May 26, 2017

TO : All Bidders
FROM : George M. Wiens
PROJECT : CTE Classroom Addition
1615400.41
SUBJECT : Addendum 1
DSA : 04-115755 / 33-H18

DRAWING NUMBER: **E3.1**

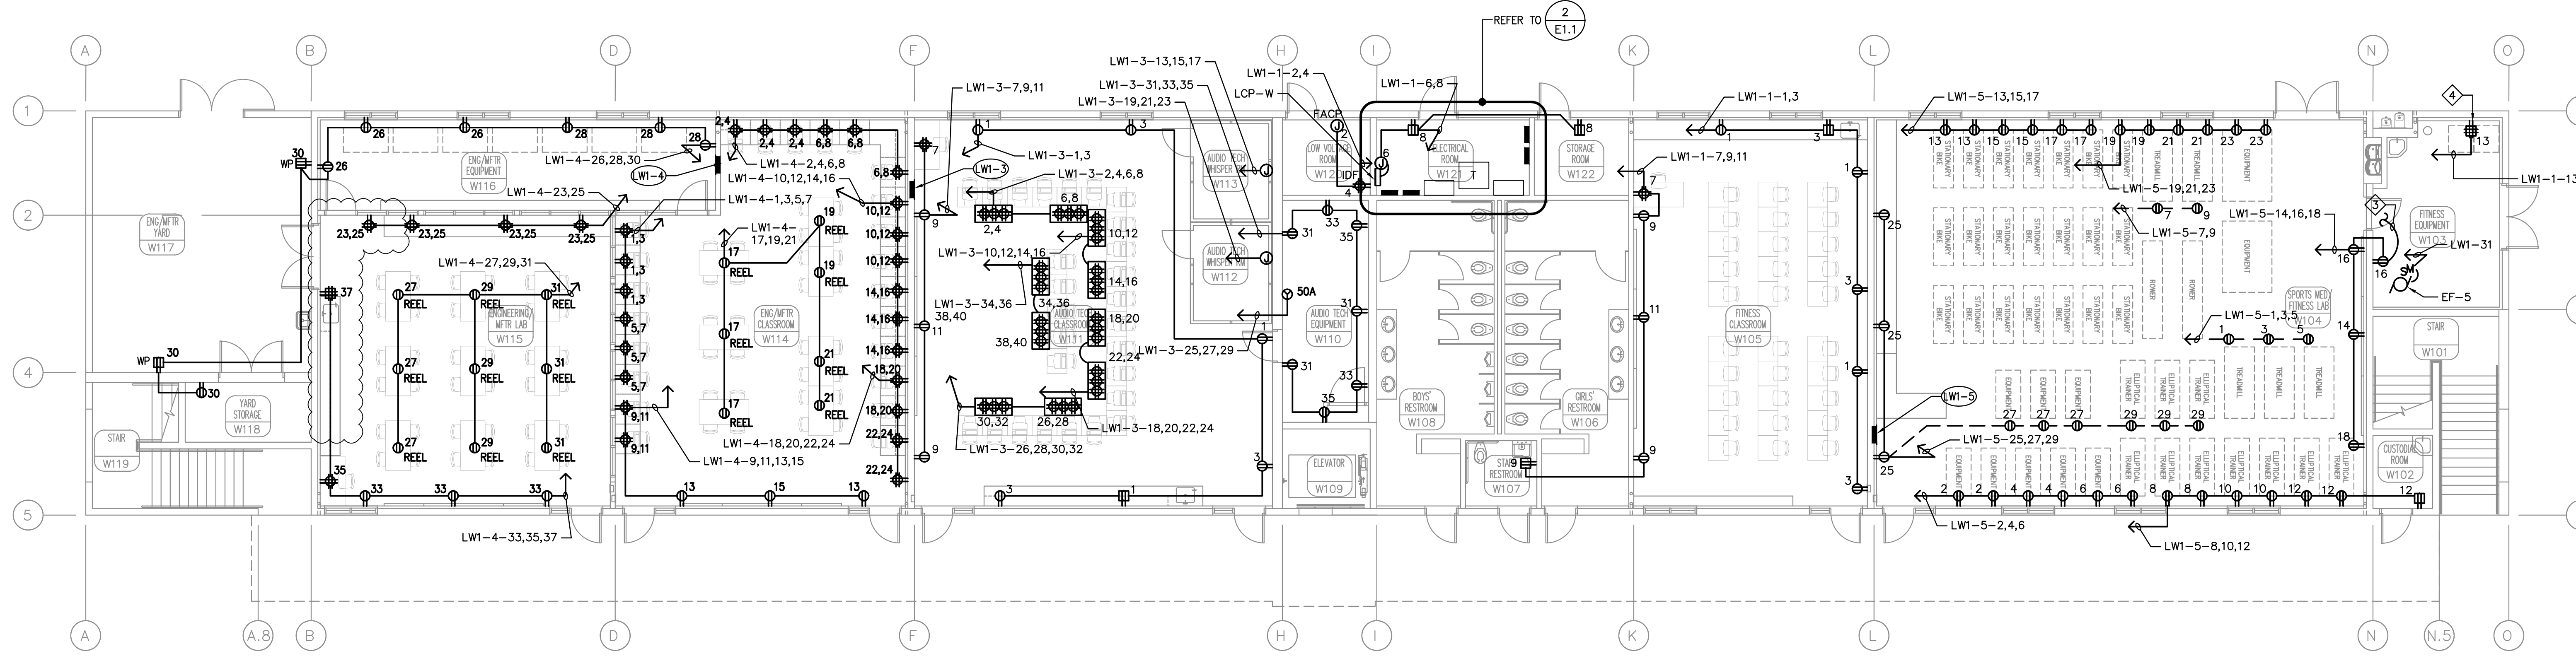
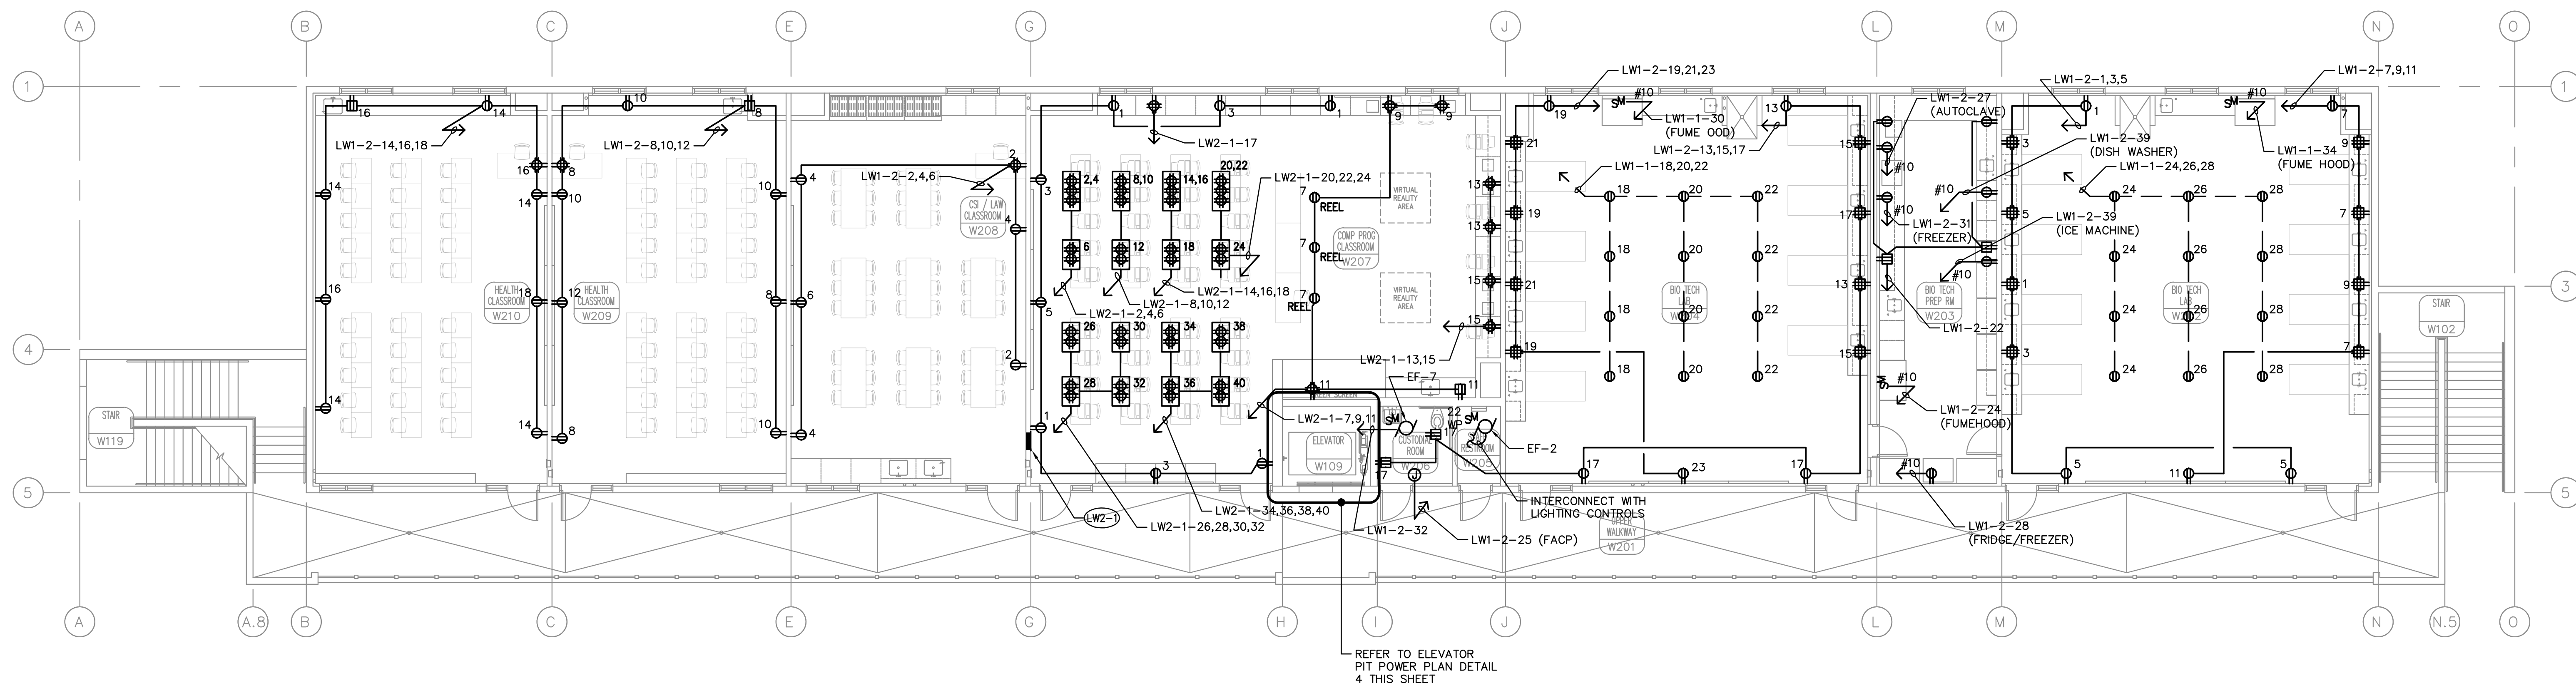
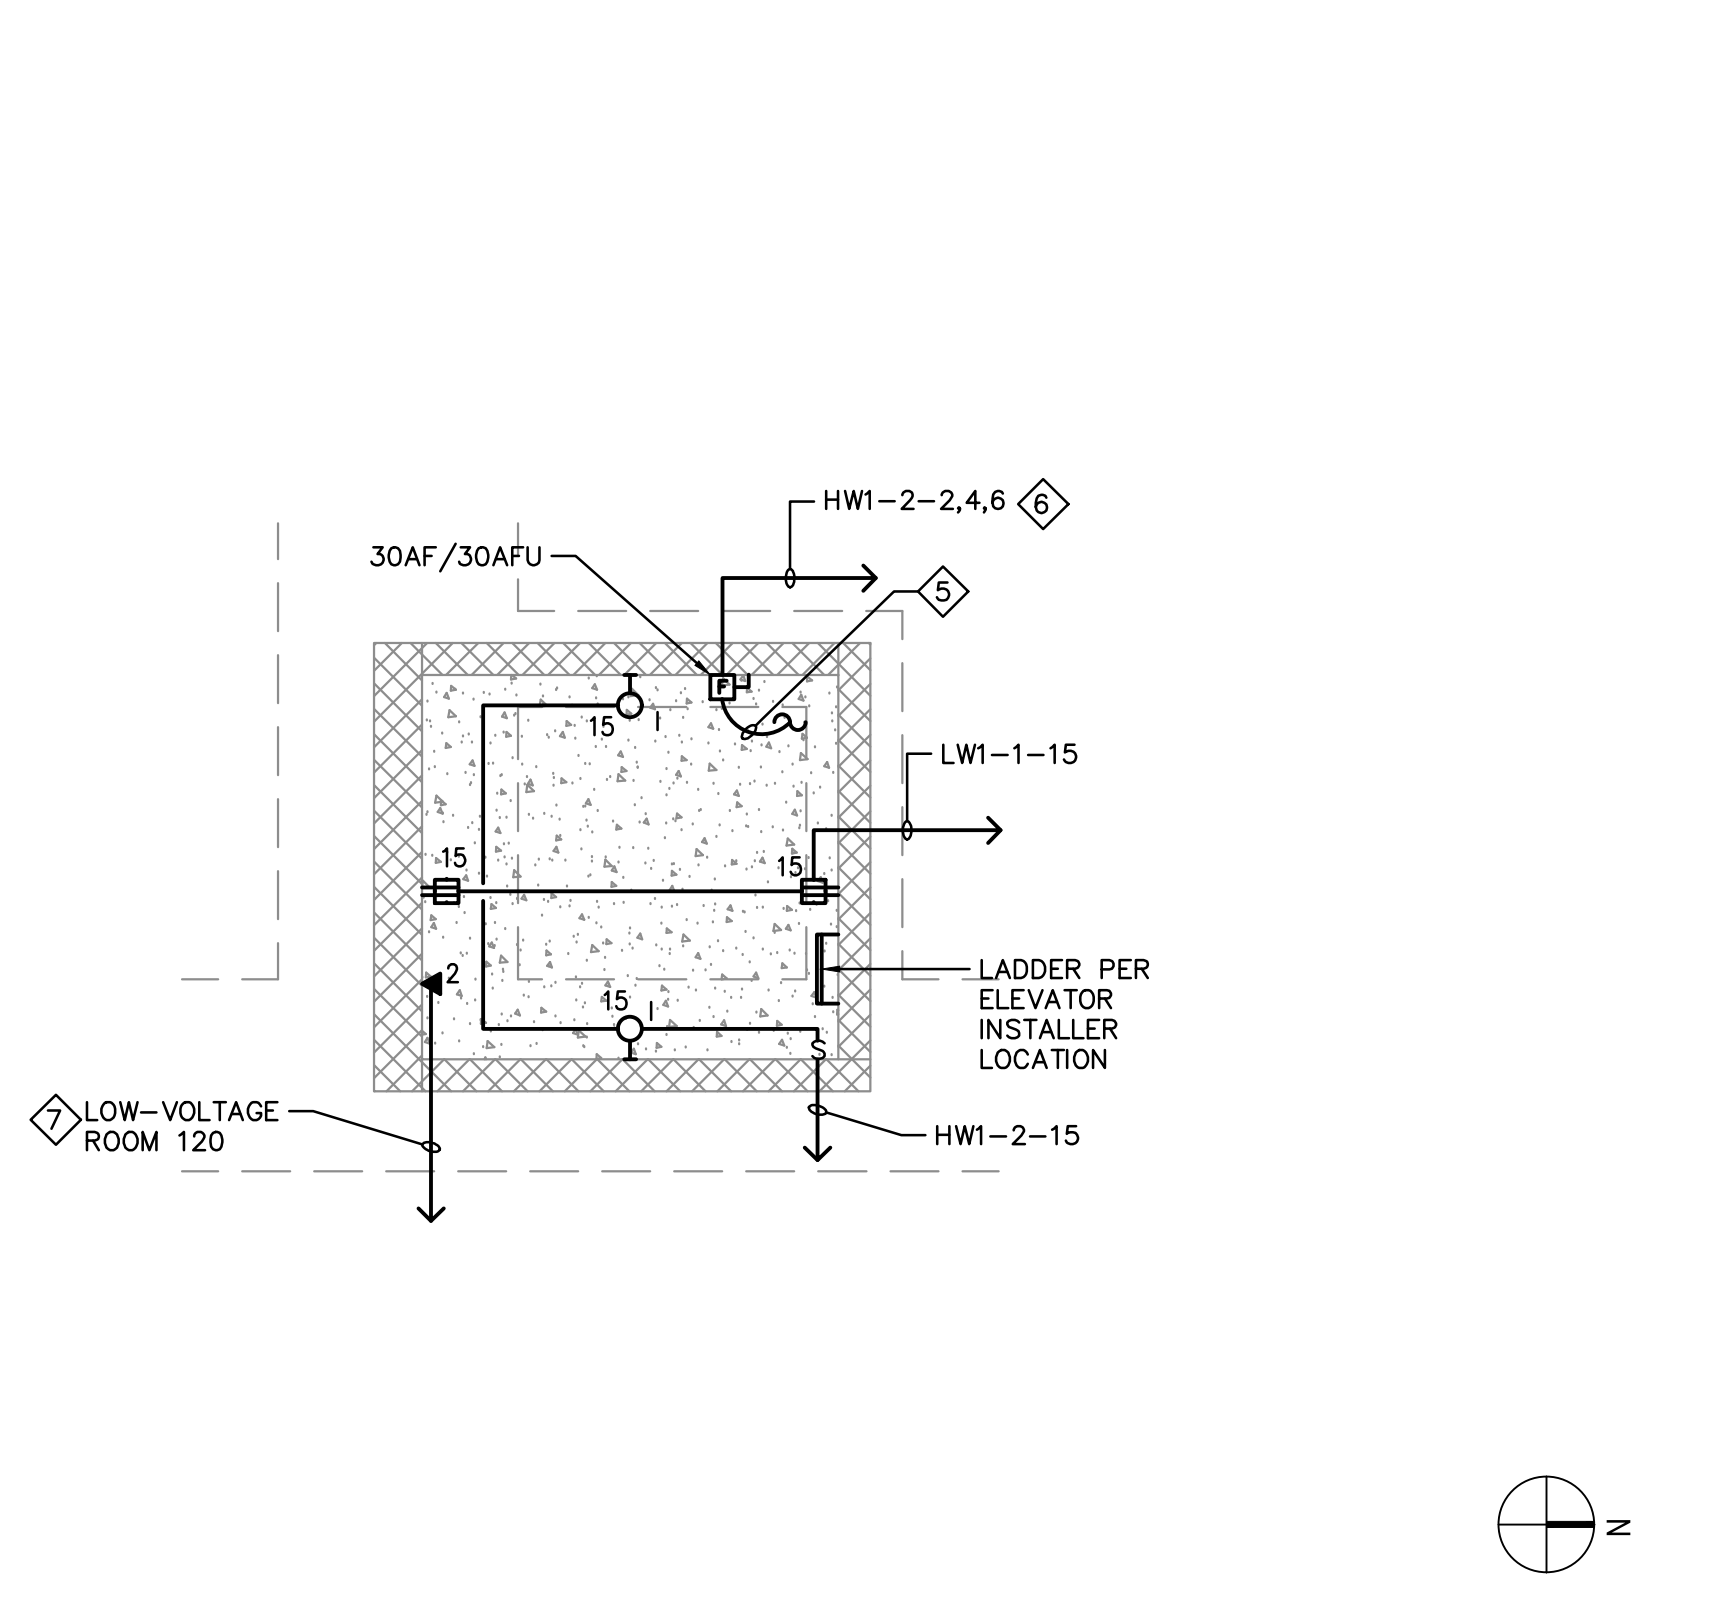
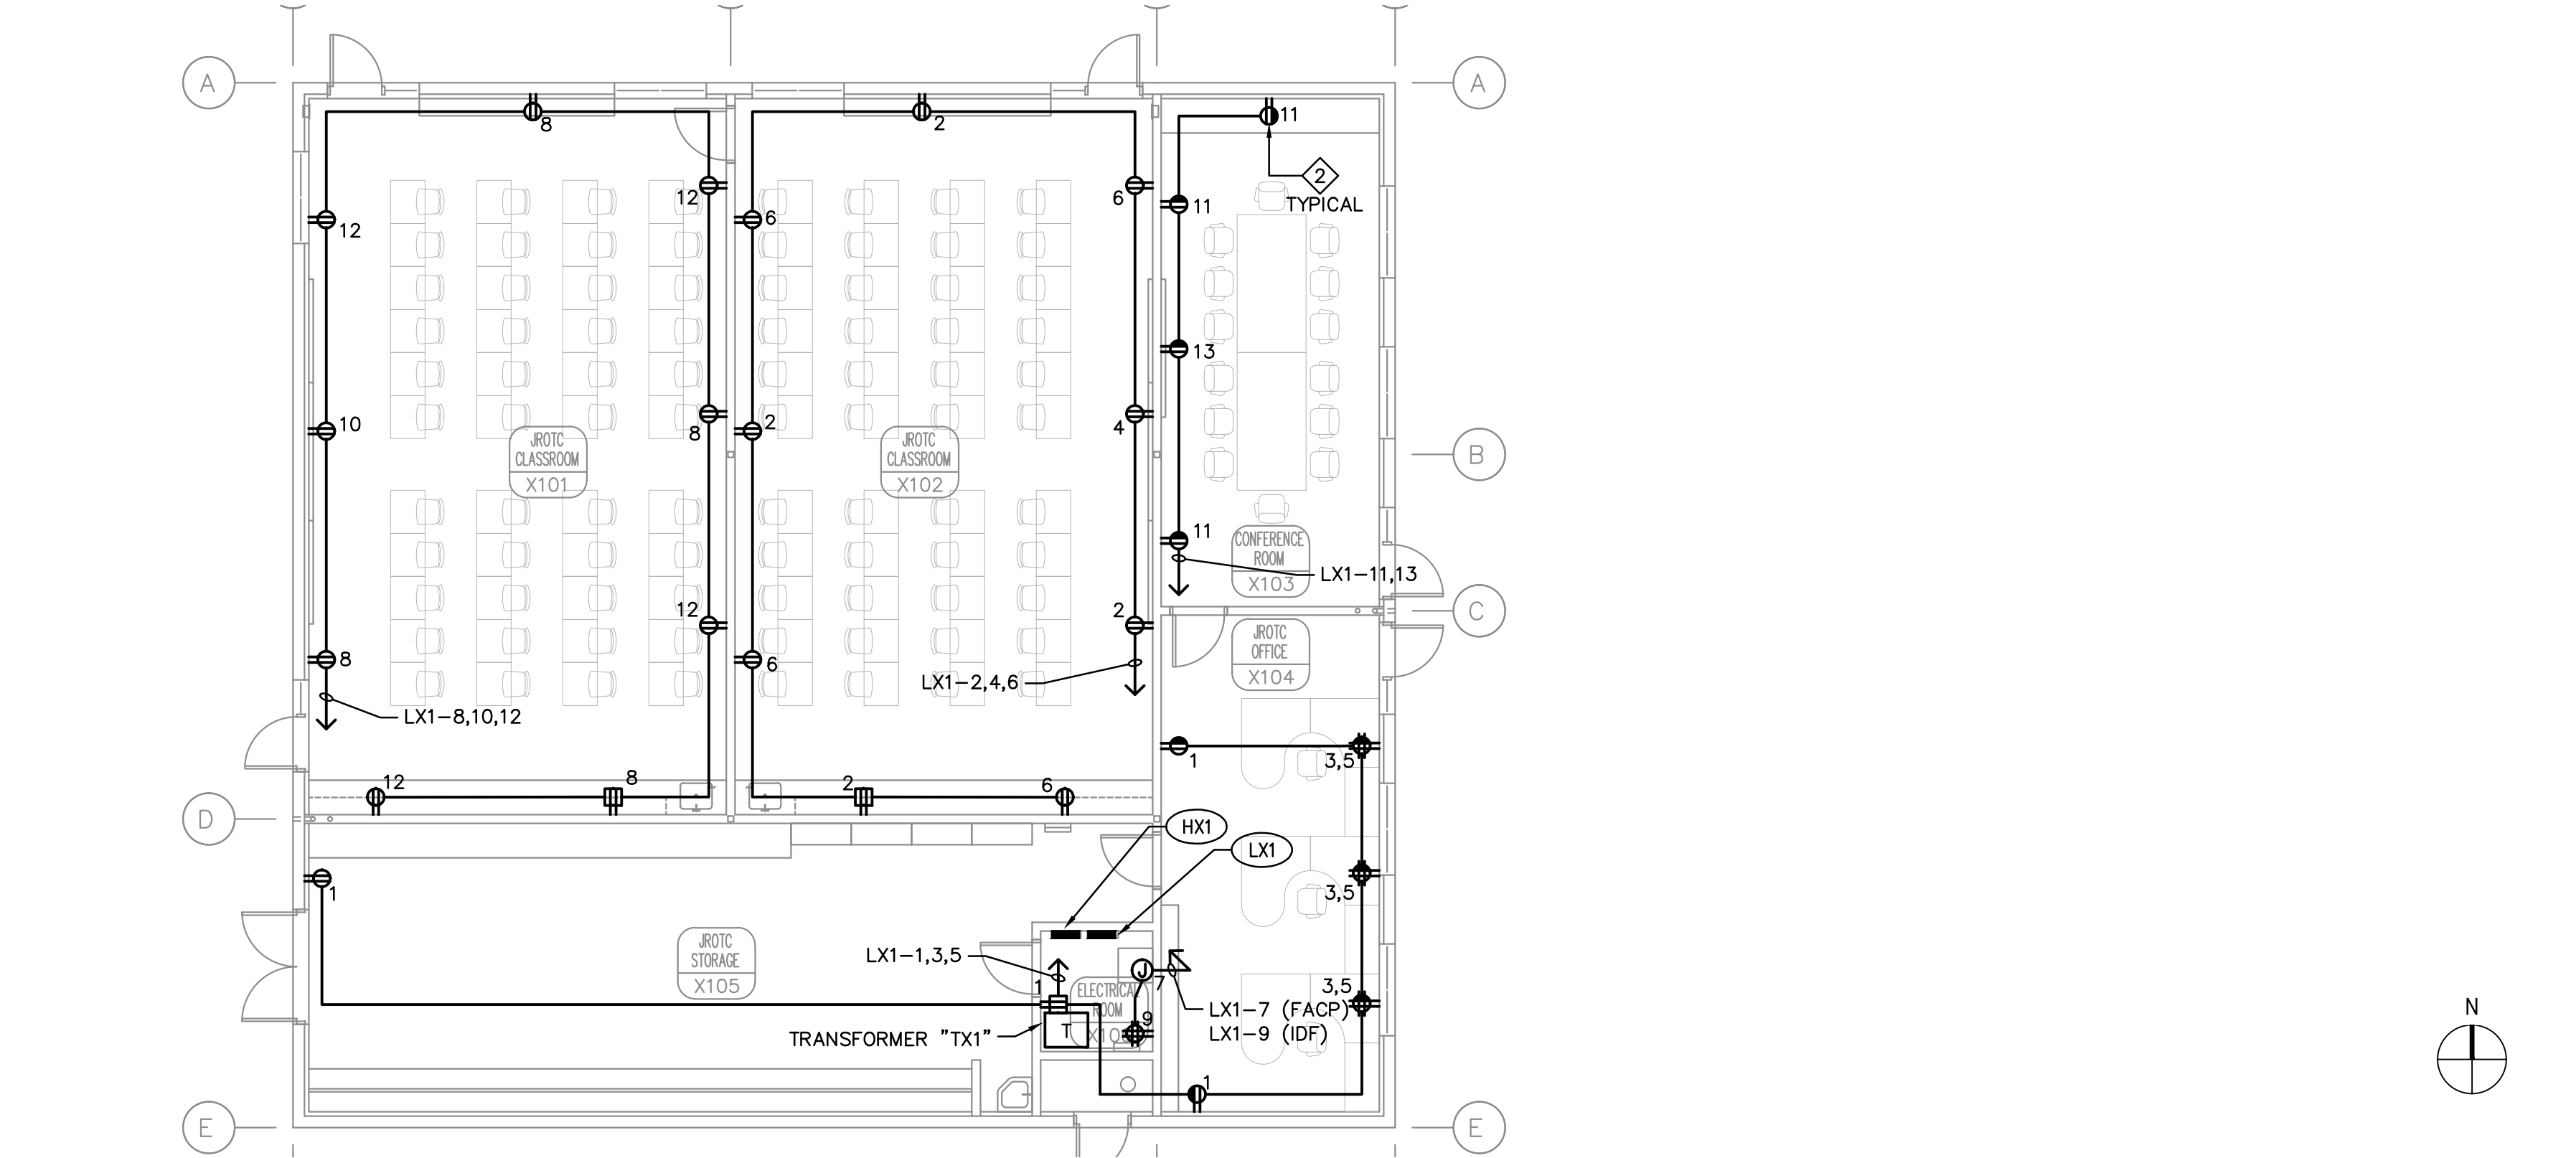
A. Revise as indicated in the clouded area labeled Delta 1 on the attached E3.1.
